Orbitex Knitwear Ltd Debonair Ltd

Gorat, Sarker Market Road, Ashulia, Dhaka - 1341
(N23.943, 90.305E)

01 June 2014

Observations

Columns vulnerable to collision loading

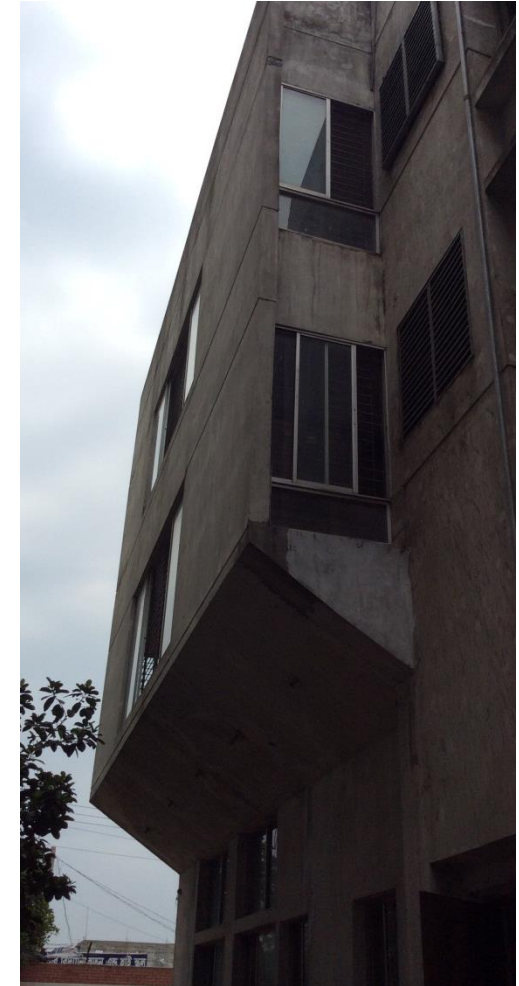
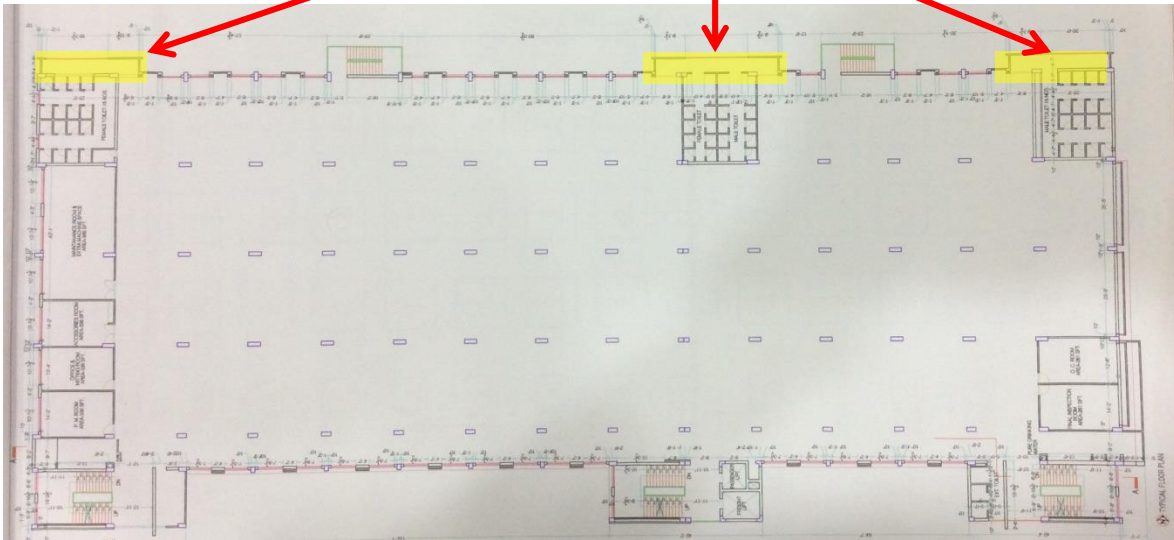
Risk of vehicle accidentally colliding with the columns to the delivery area.

At ground level, the delivery and parking area is located between columns, and no barrier was in place to protect the columns from vehicle collision.

Item No.	Observation	Recommended Action Plan	Recommended Timeline
1	Risk of vehicle accidentally colliding with the columns to the delivery area	Building Engineer to check that the columns have been adequately designed for impact loading	6-months
2	Risk of vehicle accidentally colliding with the columns to the delivery area	Suitable column protection barriers to be designed and constructed.	6-months
3	Design check for cantilever structures on north facade	The Building Engineer is to carry out a full design check of the cantilever structure and produce detailed drawings for the structural support as this is not presently shown in sufficient detail on the structural drawings.	6-months
4	Design check for slab loading in areas noted	The Building Engineer is to carry out a full design check on the slabs and beams in the areas noted to confirm their ability to transfer the loadings back to the columns.	6-months

Approximate water tank locations (roof level)

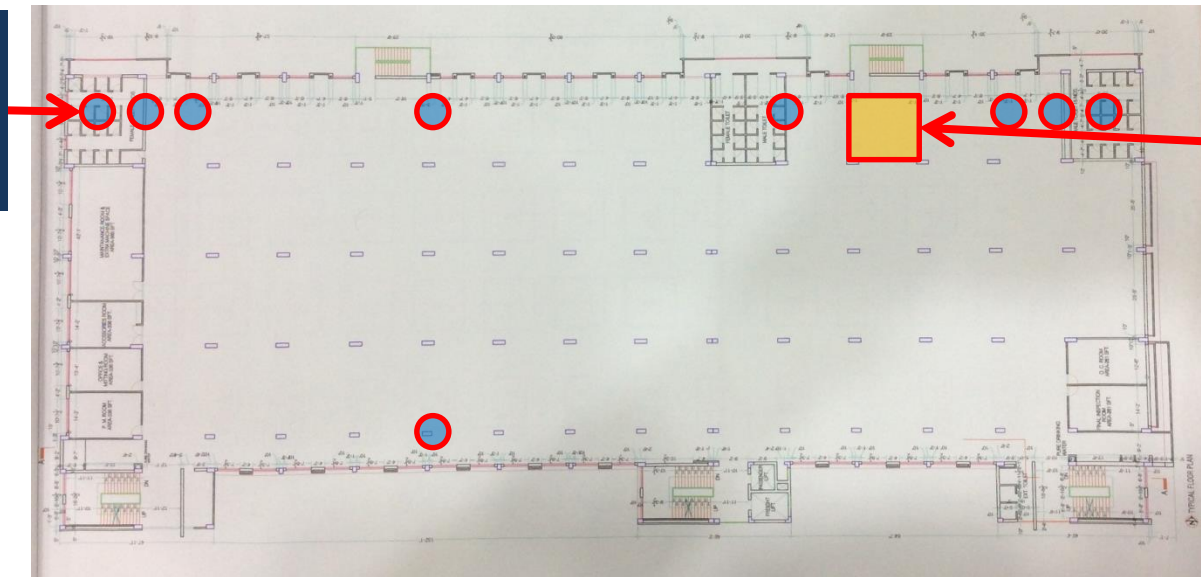
Design check for slab loading in areas noted.

Nine water tanks (5000lts each) were observed on roof level at various locations. Some were positioned directly above columns, whilst others were positioned within the bays between columns. The plinths that the tanks are positioned on varied significantly in height.

Several bays of storage were observed on level 2. Material was generally stacked to a high level.

5	Design check for slab loading in areas noted	The Building Engineer is to produce and actively manage a loading plan for all floor plates within the factory giving consideration to floor capacity and column capacity.	6-months
6	It is noted that the building has permit approval for 3 additional storeys. Any proposed additions to the existing building structure should be reviewed by the Building Engineer	If any additions to the building structure are proposed, the Building Engineer shall provide calculations showing the structural adequacy of all columns taking into account any additions to the existing structure, the loading plans and as built structure, including in-situ concrete strength testing.	6-months

Location of generator building

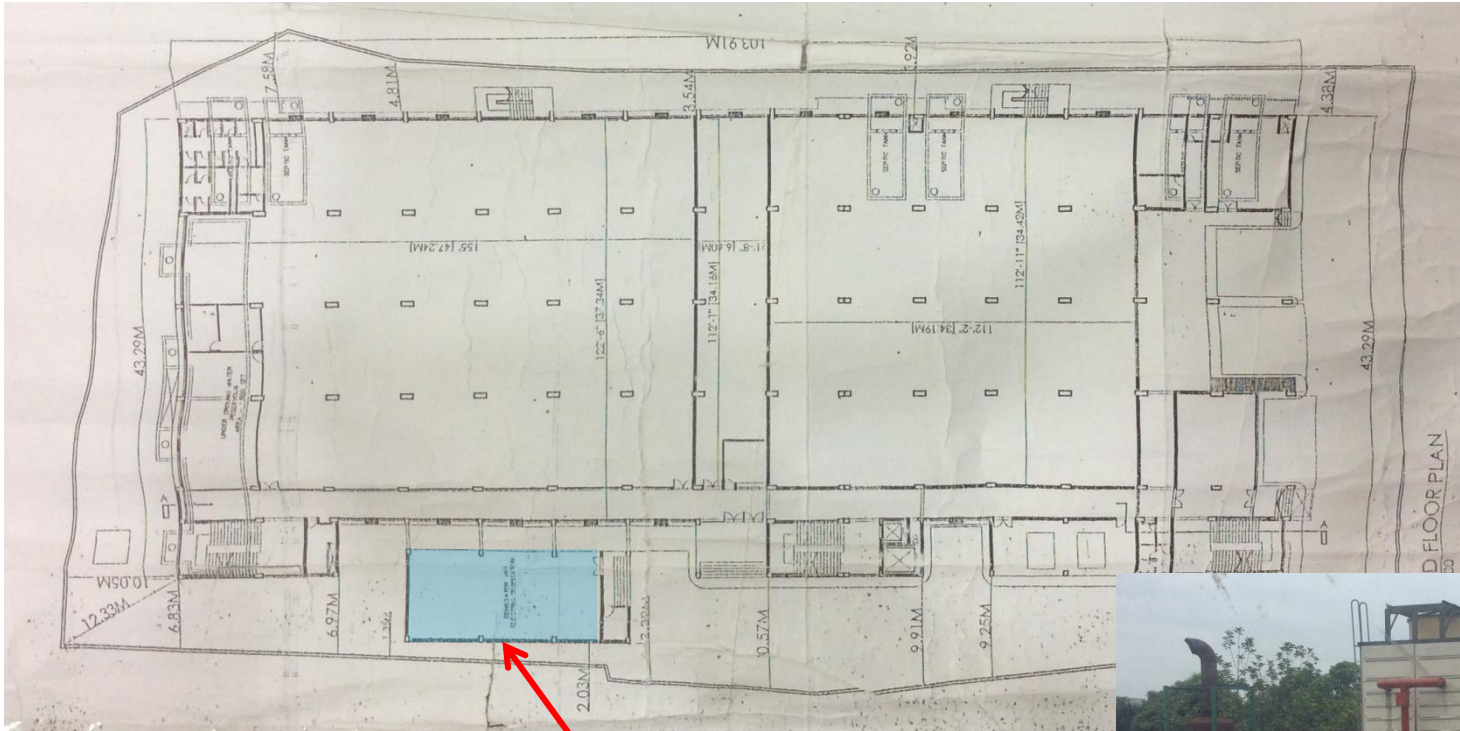
Water tanks and a Chiller were located on the roof slab of the Generator Building
